XR Vac Filter & Tank Updates

Type of Bulletin: Product Change Bulletin

This Bulletin Supersedes Bulletin(s): NA Models Affected: XR Rider Scrubber

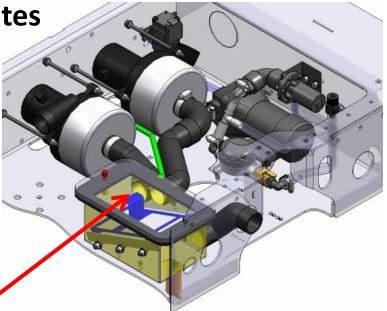
Inspection: This is not a retrofit item Correction: . The new Vacuum filter box will protect the vacuum motors further, but does require regular inspection and filter replacement. The Box still contains a drain valve at the bottom to release fluid when the vacuum motors turn OFF. The vacuum motors are now mounted in the opposite direction, which eliminates the potential for a customer to catch the hopper on cylindrical decks, and thus difficult to detect

Relocating the vacuum hose from the front to the back will reduce the potential for damaged hoses and reduced drying performance.

XR Squeegee Hose & Adjustable Bracket Update

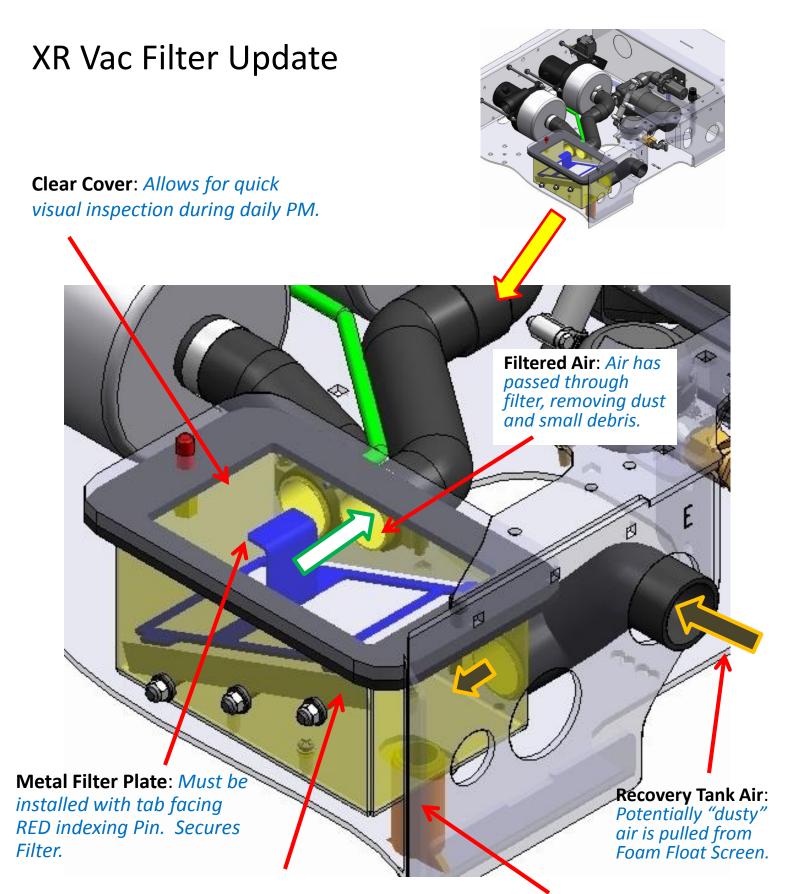
New Wider Bracket: This is part#: 370-1123 and it creates a barrier between the incoming dirty water hose from the squeegee and the stainless screen the float ball is inside. We found customers wouldn't properly install the hose into the drain saver basket.

You can see from the attached photo that when the hose is out of the basket, it was pointed directly at the screen. Also, so customers remove the drain saver basket completely. It is important that the incoming squeegee hose is properly pointed down through the hole as shown in the bottom image.

Properly Installed Hose: When installed correctly the hose is directing the dirty water into the basket, and on the opposite side of the baffle.
